**PERMIT REPORT**

From: Heidi Quinn, Permitting Technician

Re: Permit 19-064: 28th Avenue South Bridge, Minneapolis

SHEET
C2.03

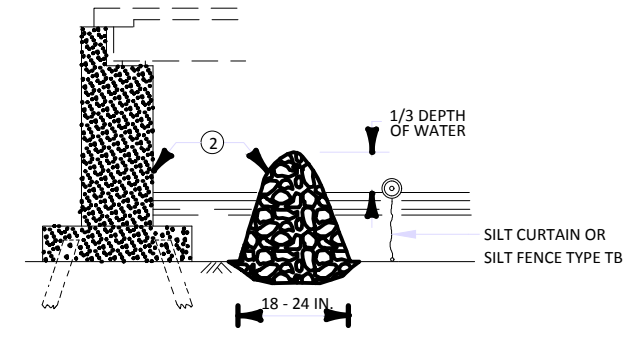
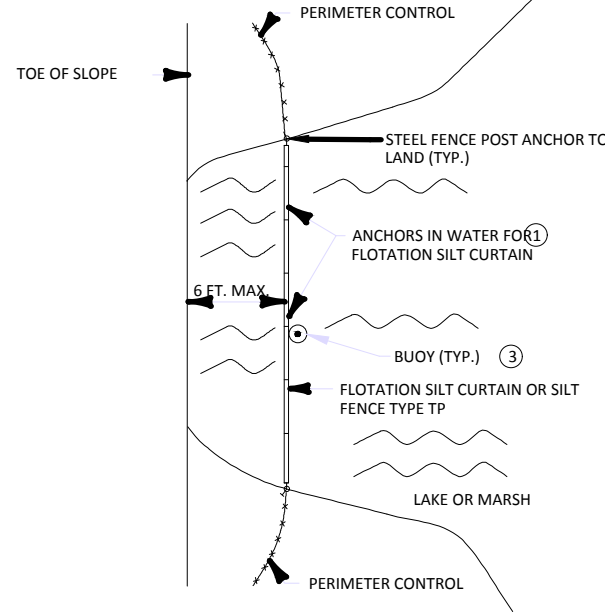
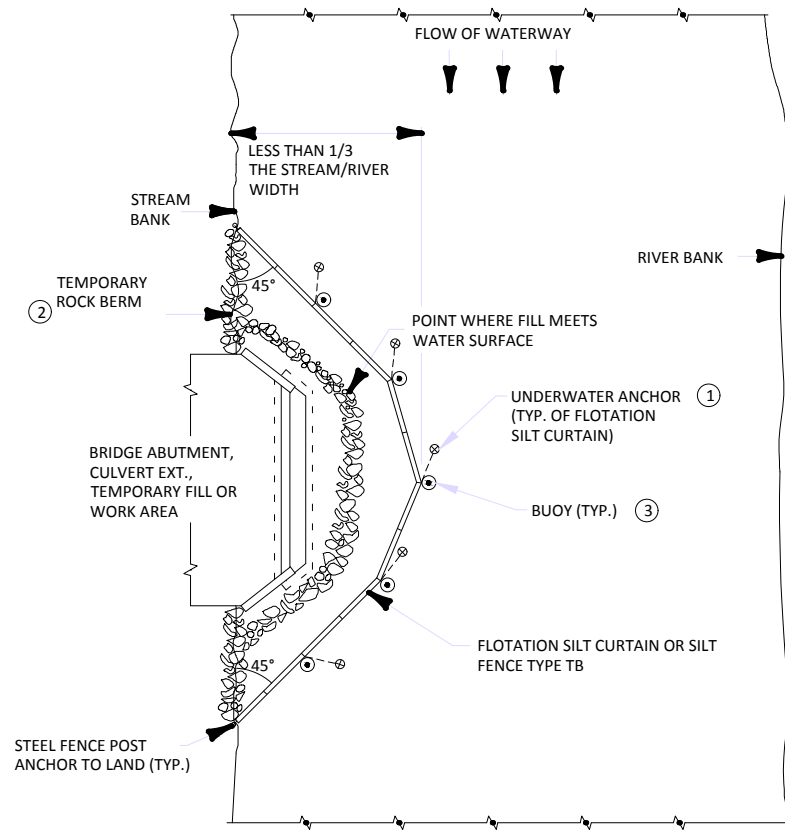
Section 5(d) of the rule requires a permanent wetland buffer monument to be installed at each lot line where it intersects the buffer, and where needed to indicate the contour of the buffer, with a maximum spacing of 100 feet. The applicant has provided a wetland buffer exhibit that demonstrates conformance with the monumentation requirement of the rule (sheet C2.03 of attachment 3).

The Applicant has submitted a wetland buffer exhibit sheet C2.03 of attachment 3) that demonstrates conformance with the decompaction requirements, erosion control plan, and native seed mix. The maintenance and monitoring requirements will be incorporated into the Wetland Protection Maintenance Agreement.
